RE: 73 GOLDHURST TERRACE, LONDON, NW6 3HA – APPLICATION REFERENCE 2021/5834/P

SM Planning have prepared this letter on behalf of the applicant at 73 Goldhurst Terrace, London, NW6 3HA in relation to the current planning application referenced 2021/5834/P for the extension of existing basement level with front and rear lightwell; infill rear extension and retention of rear dormer.

Area of proposed ground floor infill extension

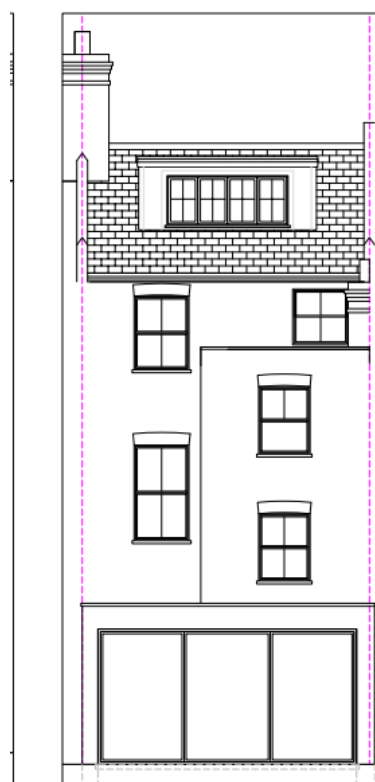
‘The proposed additional extension to what was already granted consent and implemented, due to their overall large scale and projection would overwhelm the host building and result in harm to the pattern of development and wider area. We note there are other full width extensions along the terrace, however they are either set back from the rear building line, or not project up to the principal rear elevation. As such, we would not support any further extensions to this building’.

Overall, the proposed rear extension and basement are not subordinate to the host building and they are significantly harmful to the amenity of neighbouring occupiers and to the character of the host building and pattern of development. As such, we would not be able to support this development'.

Accordingly, if an infill extension, the same as that currently proposed in my client's application (2021/5834/P), was previously considered to be acceptable based on its subordination to the host property, and against policies similar in content to the adopted CLP, similar justification can be applied to this scheme. Put simply, the ground floor infill extension would also be subordinate to the host property in that it would infill the narrow gap (only 2.3m) between the boundary wall and the side elevation of the existing single storey projection, and would not have an adverse impact on the surrounding Conservation Area. The marked-up photo below shows the small extent of the area to be infilled by the proposed ground floor extension.

As such, having regard to the small size of the ground floor extension proposed, its single storey height and those similar extensions approved at 49 and 87 Goldhurst Terrace, the proposed ground floor infill extension is both subordinate to the host building and in keeping with the character of the host building and pattern of development.
